UNITED STATES ENVIRONMENTAL PROTECTION AGENCY

Subject: Notice of Disapproval of:

- Draft Remedial Investigation Report, Operable Unit 3, dated March 30, 2018 ("Draft OU3 RI Report")
 - Draft Baseline Human Health Risk Assessment, Operable Unit 3, dated March 30, 2018 ("Draft OU3 BHHRA")
 - Draft Operable Unit 1 & Operable Unit 2 Feasibility Study, dated March 30, 2018 ("Draft OU1 and OU2 FS Report")
 - Draft Operable Unit 3 Feasibility Study, dated March 30, 2018 ("Draft OU3 FS Report")
 - Containment Area Bedrock Boring Results, Olin Chemical Superfund Site (OCSS) in Wilmington MA, dated May 10, 2018
 - Revised Rock Matrix Sampling Work Plan (July 6, 2018) and related information provided by Olin/Wood in a letter dated June 29, 2018
- (Collectively, the "March 2018 RI/FS Deliverables"), Olin Chemical Superfund Site, Wilmington, Massachusetts ("Site")

Main Street “Saddle” Reinterpreted

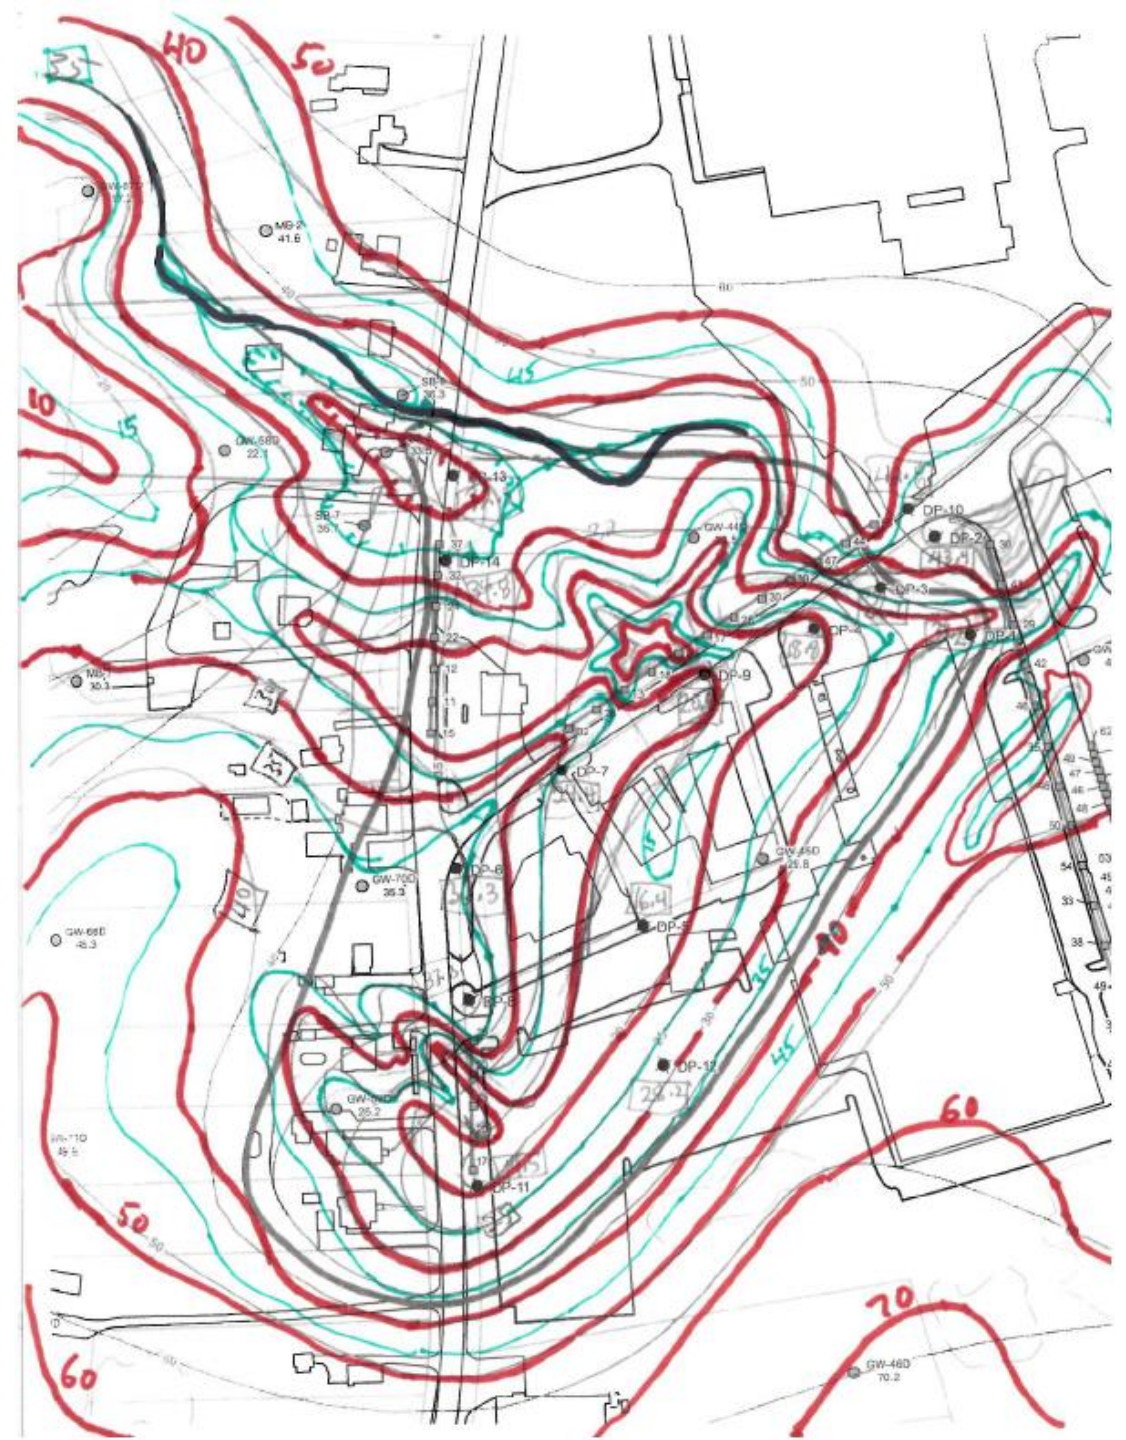
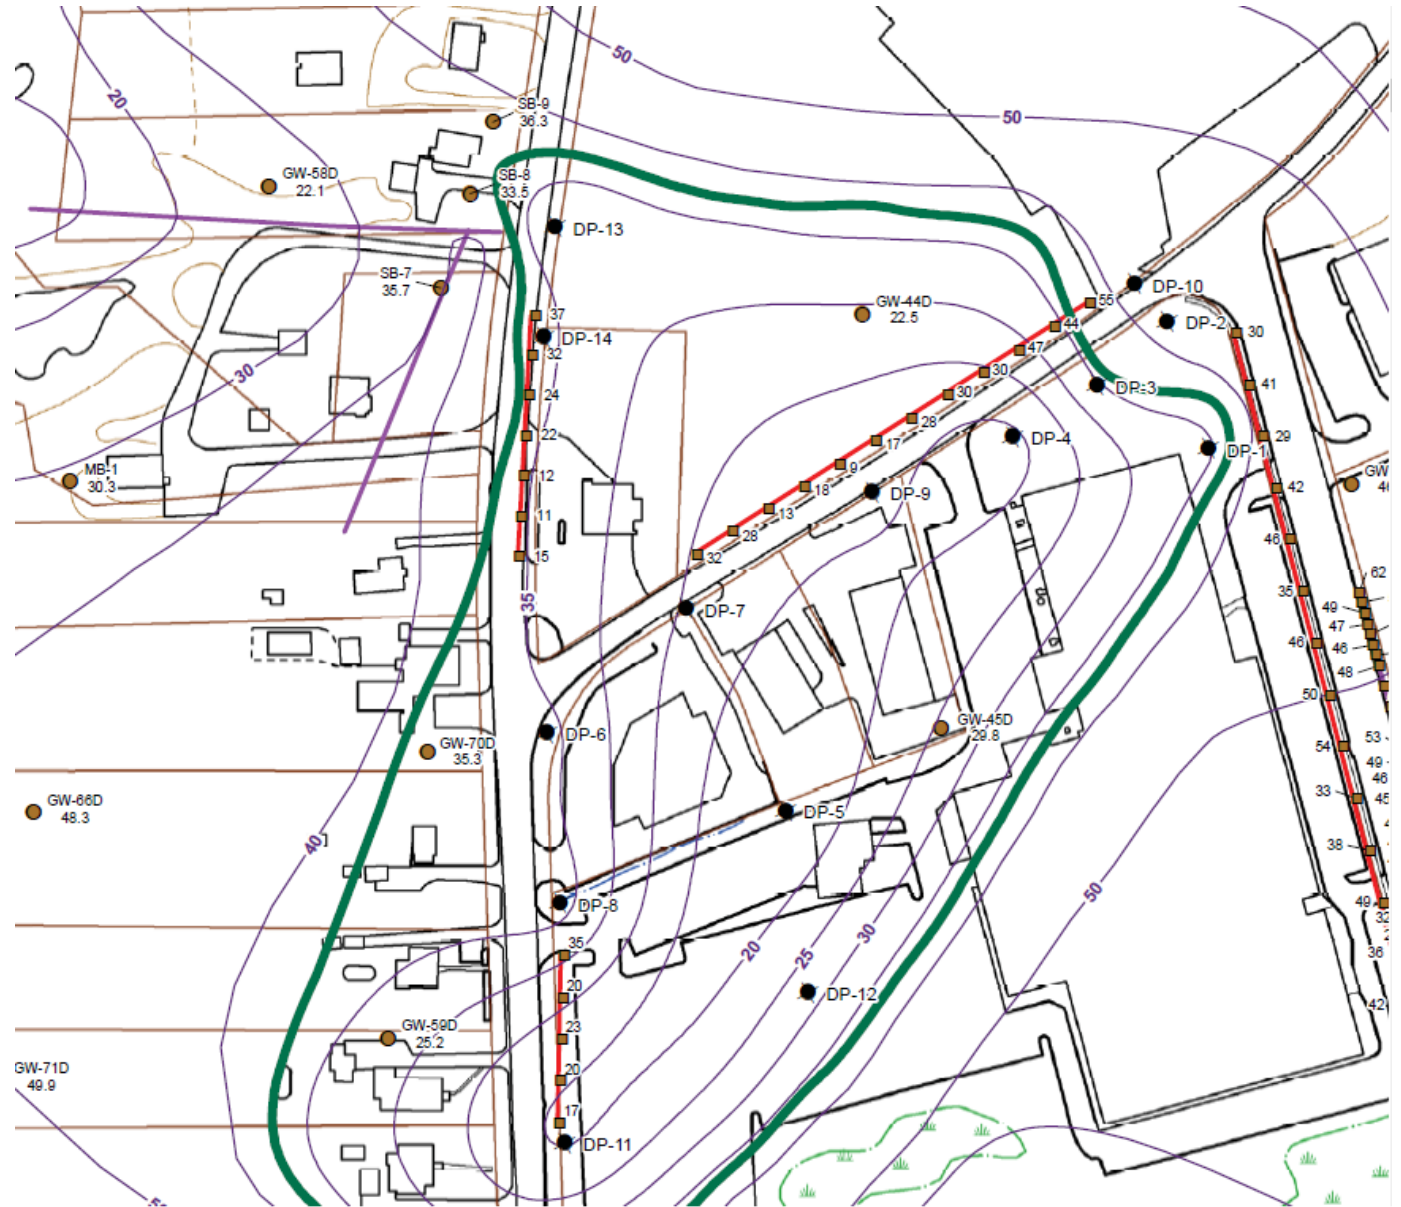
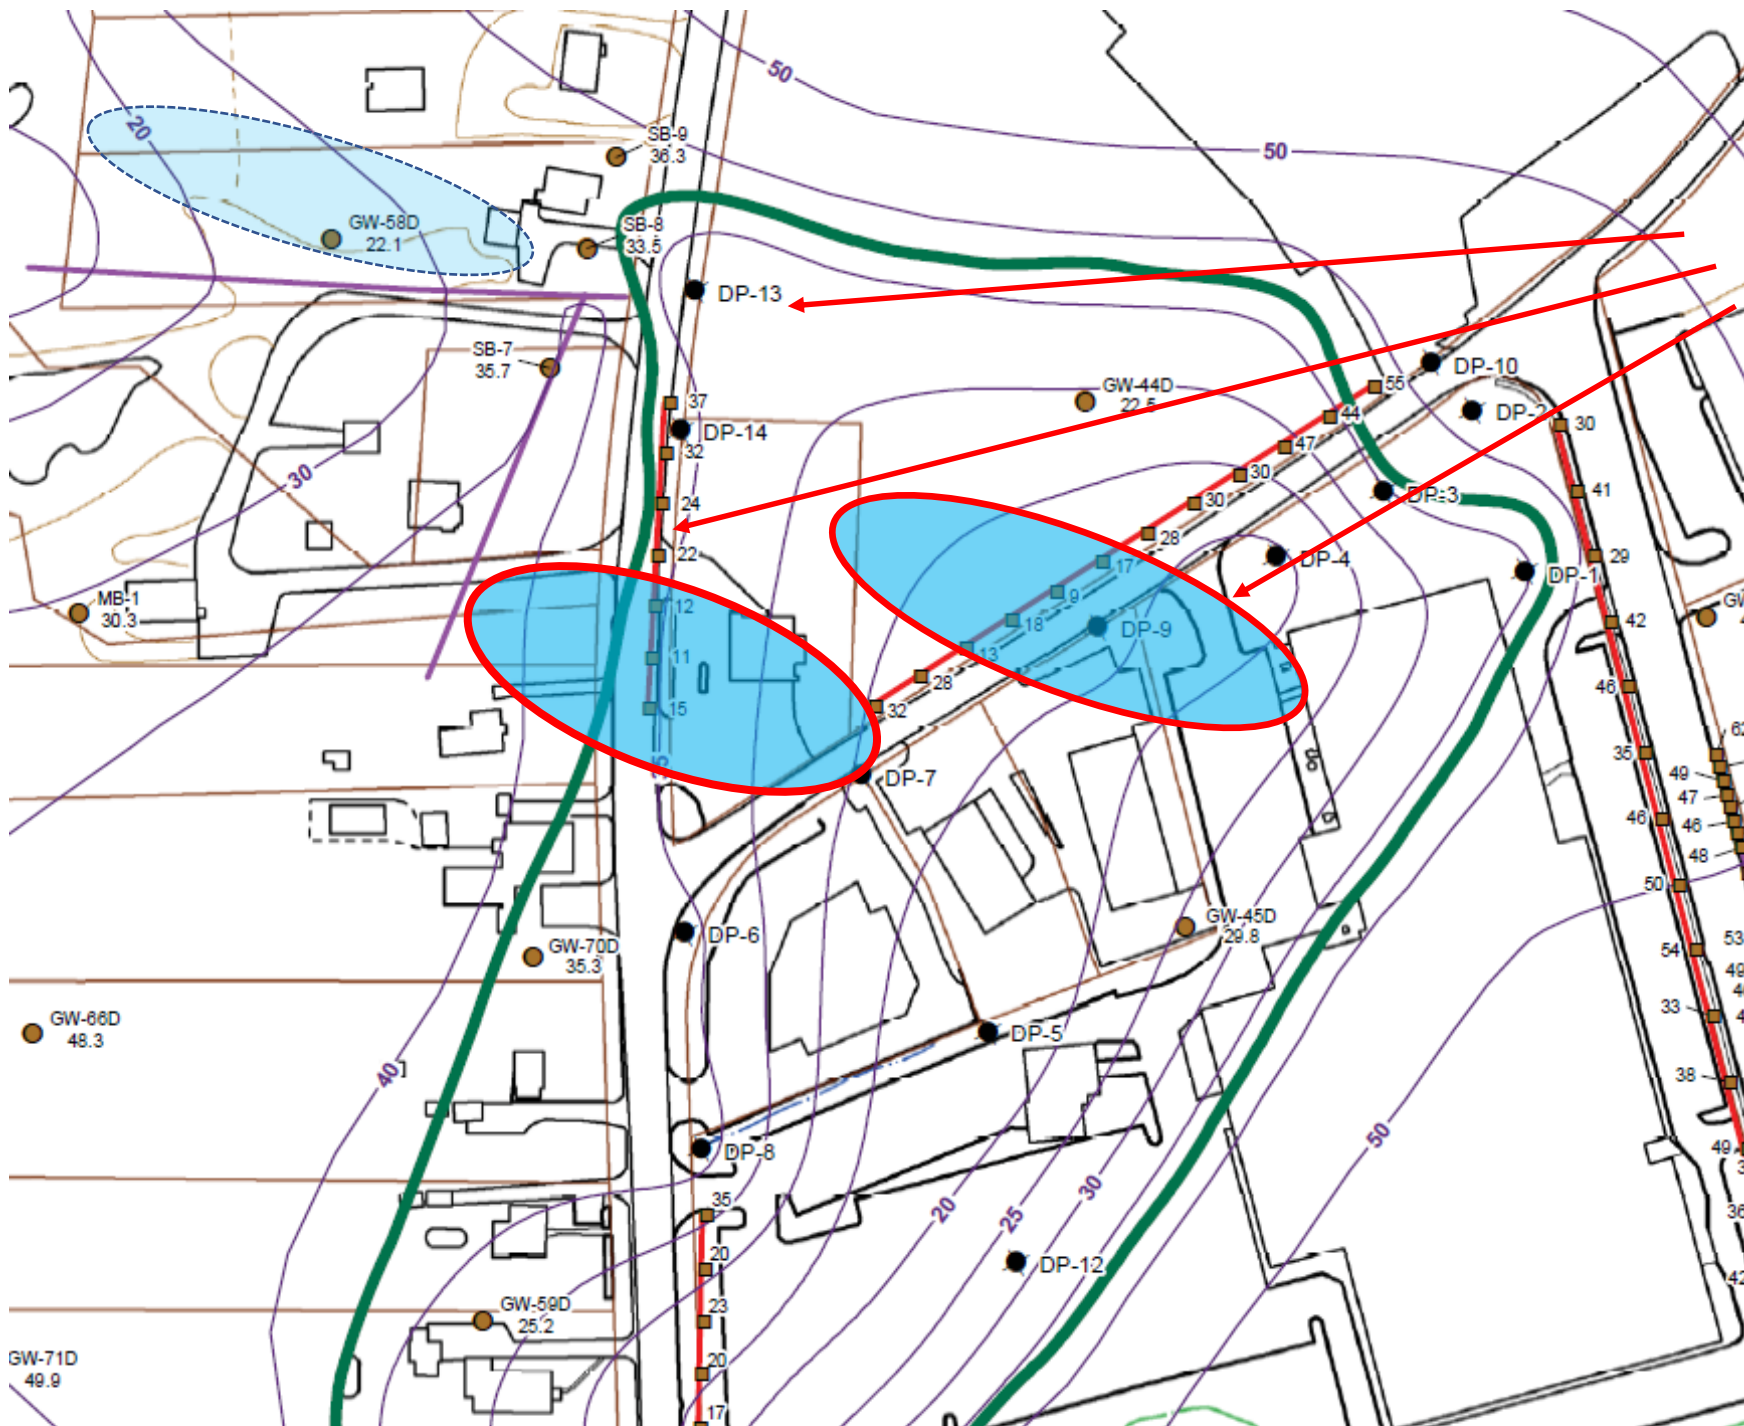
- Honors all data presented:
- TOR elevations from seismic
 - elevations supplied by others
 - Seismic 'picks' not verified
- TOR elevations from Boring data
- TOR surface reinterpreted and hand-contoured

Appendix 1 – Attachment 1 shows a reinterpreted top-of-bedrock elevation map based on data presented in the RI. This interpretation, while a non-unique representation of the data, honors many data points which were ignored or misinterpreted in Figure 2.2-9 presented in the RI. Key aspects of this alternative re-interpretation are as follows:

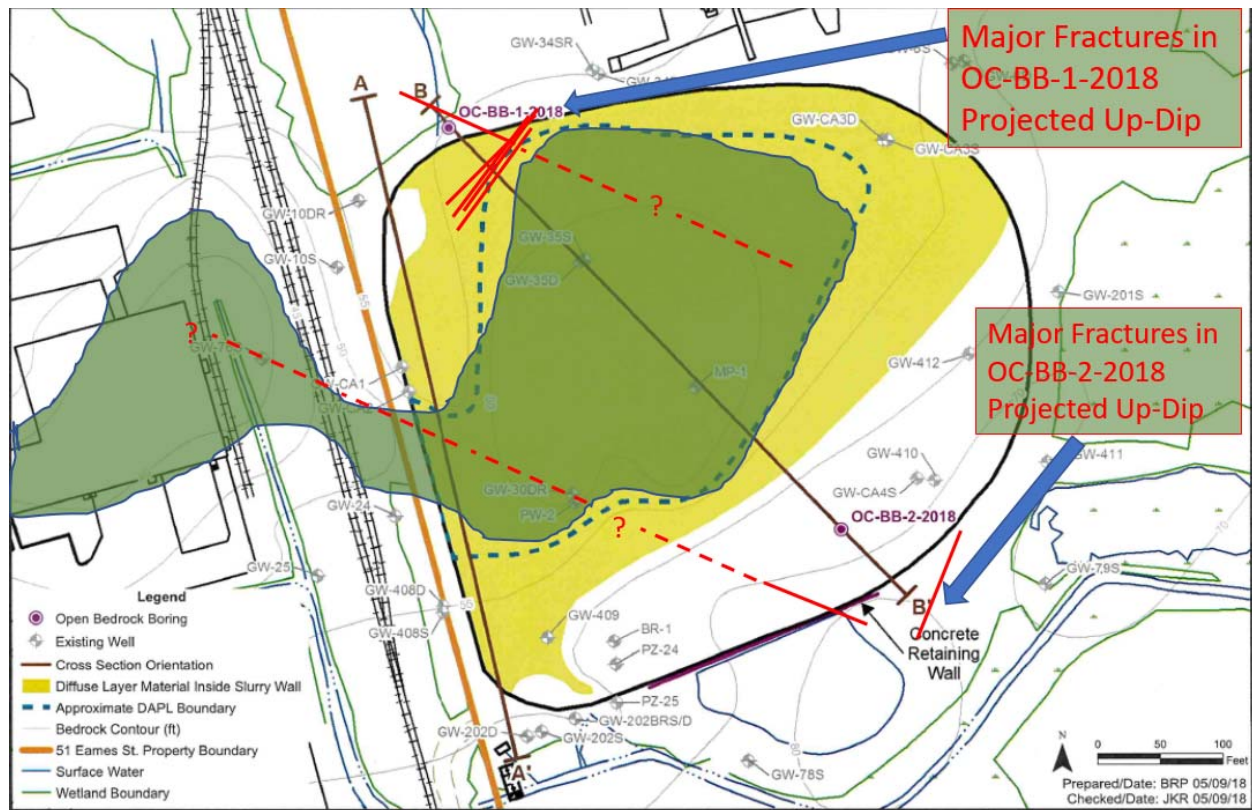
Northwest-striking fractures - Steeply dipping; Steeply-dipping fractures of NW-SE strike are common in the northeast U.S. and are commonly of significant importance hydraulically. The steep dip angles, near vertical in many cases, however, make these difficult to intersect with randomly located bedrock boreholes. These difficulties notwithstanding, the available Site data suggests that such features are present across the site, and are therefore of potential importance and deserving of future focused efforts. The limited containment area study corroborates this. Both OC-BB-1-2018 and OC-BB-2-2018 intersected steeply dipping NW-SE striking fractures of potential hydraulic significance.

It is noted that in each of these boreholes, the steeply dipping NW-SE striking fractures can be projected upward into the containment area. While the strike length of these features is not known, specific features of this orientation intersected by OC-BB-1-2018 and OC-BB-2-2018 have at least the *potential* to "daylight" beneath the containment area, and may thus provide a pathway into bedrock.

This potential pathway needs to be further assessed. As recommended previously, favorably oriented surface geophysical surveys shall be employed to identify specific drilling targets for future

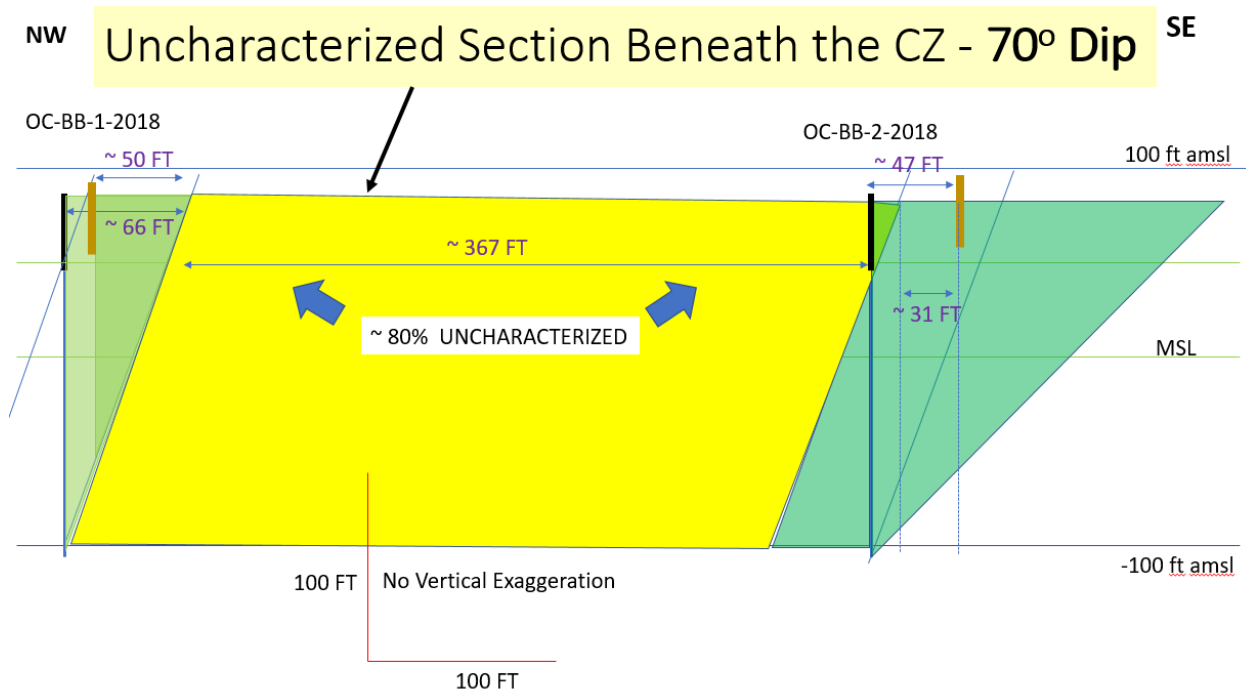
1. *Executive summary*; Page 1, 3rd ¶; The text states “The boring inside the Containment Area and immediately adjacent to the associated DAPL pool encountered un-fractured and highly competent bedrock over the entire borehole (to a depth of approximately 180 feet below ground surface (bgs)). The boring outside the area had only one likely water bearing fracture, which was at a depth well below the DAPL (approximately 175 feet bgs). The borings corroborate the previous findings that bedrock underlying the Containment Area is highly competent and no additional investigation is warranted to verify the competency of the bedrock in the vicinity.” EPA is unable to concur with these sweeping but inaccurate conclusions as they lack technical support or are in some cases contrary to existing information, including data from the new boreholes. For example, a very significant fracture occurs at a 32.3 feet bgs in OC-BB-2-2018, just below the base of the steel casing. The fracture has a huge aperture (32 mm), which is the largest measured in either of the two borings, as well as a demonstrable relationship to flow based on pumped HPFM data. Clearly the generalization of “un-fractured” conditions “over the entire borehole” is not accurate. Similarly, the “one likely water bearing fracture” discussed relative to OC-BB-1-2018 (at 176.0 bgs) is not the *only* one identified on the geophysical logs.

While the fracture discussed here appears to be the largest and most significant with respect to flow, additional notable fractures were identified by Olin's geophysical contractor at 104.9, 106.3, 114.7, and 116.6 feet bgs, and drilling logs suggest the presence of additional potential fracture zones not detected by the geophysical surveys, particularly in the uppermost 70 feet of the borehole. While it is not clear what "previous findings" are supported by the current efforts, EPA disagrees with the statement that *"bedrock underlying the Containment Area is highly competent and no additional investigation is warranted to verify the competency of the bedrock in the vicinity."* The basis for EPA's position is presented in comments provided in this appendix as well as Appendix 1. Therefore, these statements must be deleted from the report and replaced with EPA's summary of the CSM for this area. In addition, EPA has provided comments suggesting further work needed that would help refine EPA's CSM for this area.
